**Subject: MHI's Responses to US-APWR DCD RAI No. 191-2048 Revision 0**

Responses to Request for Additional Information No. 191-2048  
Revision 0

**RAI NO.:** NO. 191- 2048 REVISION 0  
**SRP SECTION:** 14.03.04 - Plant Systems- Inspections, Tests, Analyses, and Acceptance Criteria  
**APPLICATION SECTION:** DCD SECTION 2.7.1  
**DATE OF RAI ISSUE:** 02/09/2009

Figure 2.7.1.2-1 Main Steam Supply System

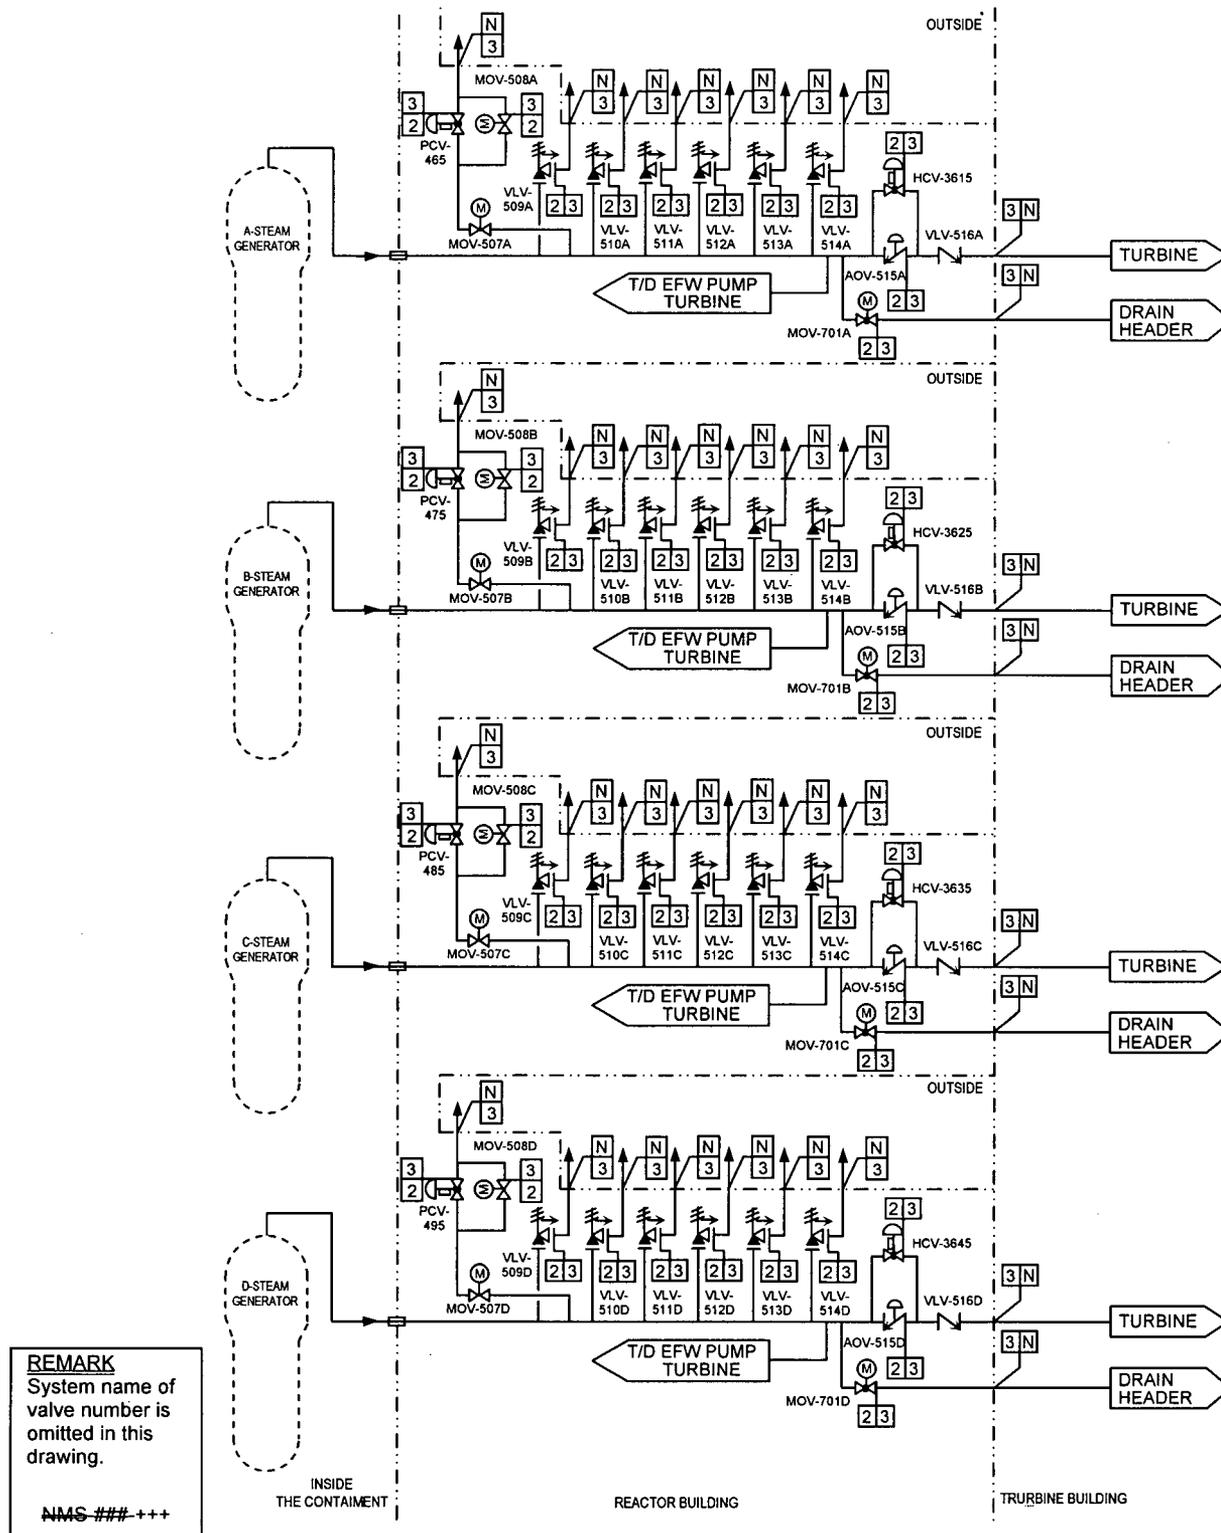
12. Page 2.7-18, Figure 2.7.1.2-1, Lower Right Corner, "TRUBINE BUILDING" should be "TURBINE BUILDING."
13. Page 2.7-31, Section 2.7.1.9.1, Design Description- Alarms, Displays, and Controls, First Sentence; "Table 2.7.1.9-3 identifies alarms" should be "Table 2.7.1.9-4 identifies alarms."

The above changes will be incorporated in DCD Tier 1, Section 2.7, Revision 2, with the following exceptions:
